NINE MILE POINT NUCLEAR STATION, UNIT 1

AMENDMENT TO FACILITY OPERATING LICENSE

Amendment No. 95
License No. DPR-63

AMENDMENT NO. 95 TO FACILITY OPERATING LICENSE NO. DPR-63

FIGURE 3.2.2.a

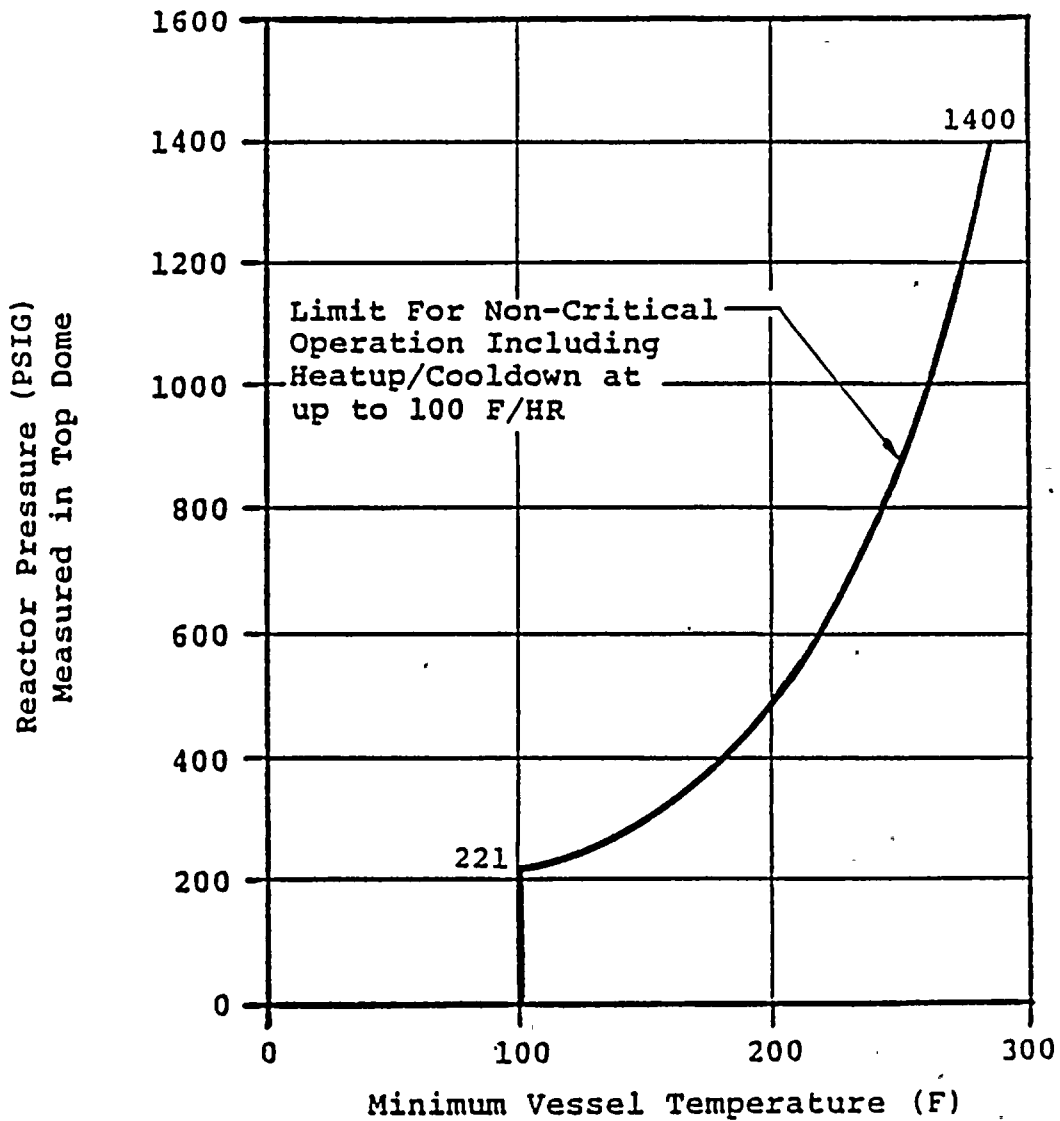
MINIMUM TEMPERATURE FOR PRESSURIZATION DURING
 HEATUP OR COOLDOWN (REACTOR NOT CRITICAL)
 (HEATING OR COOLING RATE ≤ 100 F/HR) FOR UP TO
 THIRTEEN EFFECTIVE FULL POWER YEARS OF CORE OPERATION

Figures 3.2.2.a and 3.2.2.b are plots of pressure versus temperature for a heat-up and cool down rate of 100F/hr. maximum. (Specification 3.2.1). Figure 3.2.2.c is a plot of pressure versus temperature for hydrostatic testing. These curves are based on calculations of stress intensity factors according to Appendix G of Section III of the ASME Boiler and Pressure Vessel Code 1980 Edition with Winter 1982 Addenda. In addition, temperature shifts due to integrated neutron flux at thirteen effective full power years of operation were incorporated into the figures. These shifts were calculated from the formula presented in Regulatory Guide 1.99, proposed Revision 2. These curves are applicable to the beltline region at low and elevated temperatures and the vessel flange at intermediate temperatures. Reactor vessel flange/reactor head flange boltup is governed by other criteria as stated in Specification 3.2.2.d. The pressure readings on the figures have been adjusted to reflect the calculated elevation head difference between the pressure sensing instrument locations and the pressure sensitive area of the core beltline region.

Figures 3.2.2.a., 3.2.2.b. and 3.2.2.c. have incorporated a temperature shift due to the calculated integrated neutron flux. The integrated neutron flux at the vessel wall is calculated from core physics data and has been measured using flux monitors installed inside the vessel. The curves are applicable for up to thirteen effective full power years of operation.

FIGURE 3.2.2.c

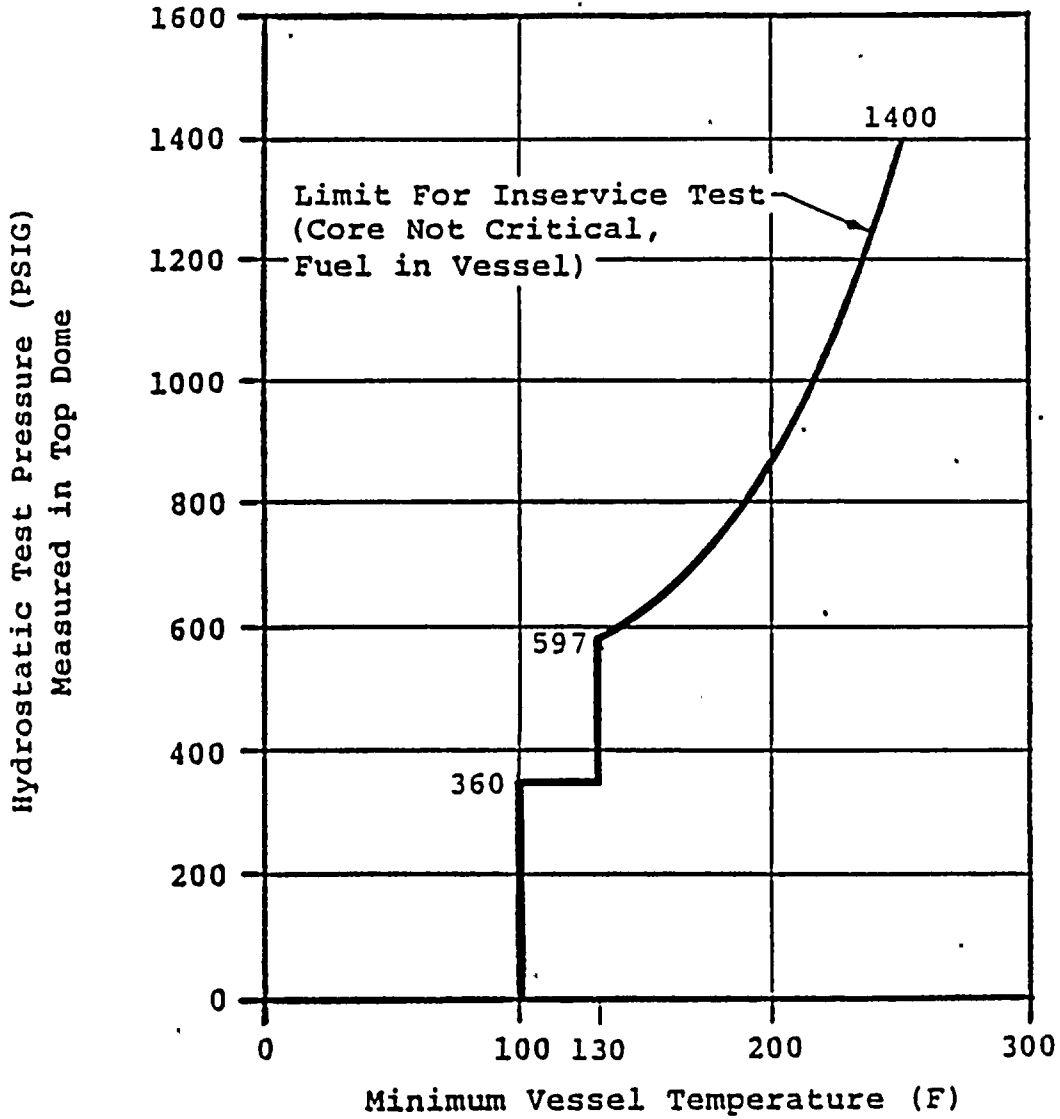
MINIMUM TEMPERATURE FOR PRESSURIZATION DURING
 HYDROSTATIC TESTING (REACTOR NOT CRITICAL) FOR UP TO
 THIRTEEN EFFECTIVE FULL POWER YEARS OF CORE OPERATION
